CITY OF KYLE

Planning and Zoning Commission Workshop Meeting

Discussion Streetlight Amendments

Sec. 41-146. - Streetlights.

Figure 32 – Pole Spacing

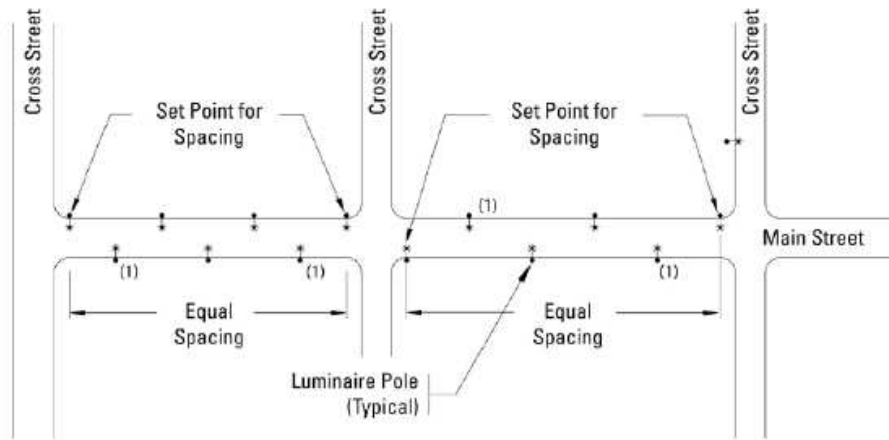
(3) If the block length is over 600 feet but less than increments of 300 feet, the light shall be placed in mid-block to the degree practical. For the purposes of this subsection, streetlights are still required at intersections. See example below, Figure 32.

Figure 32 – Pole Spacing

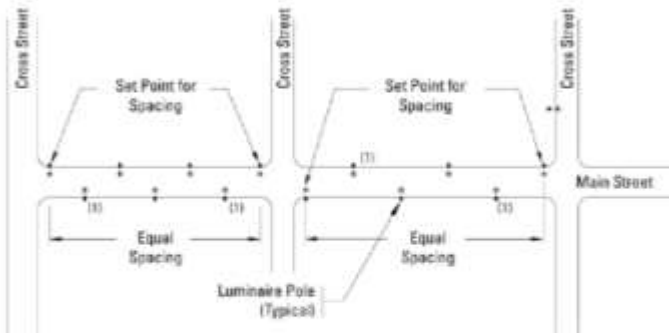
- (3) If the block length is over 600 feet but less than increments of 300 feet, the light shall be placed in mid-block to the degree practical. For the purposes of this subsection, streetlights are still required at intersections. See example below, Figure 32.

Commented [WA7]: Ensure adequate lighting.
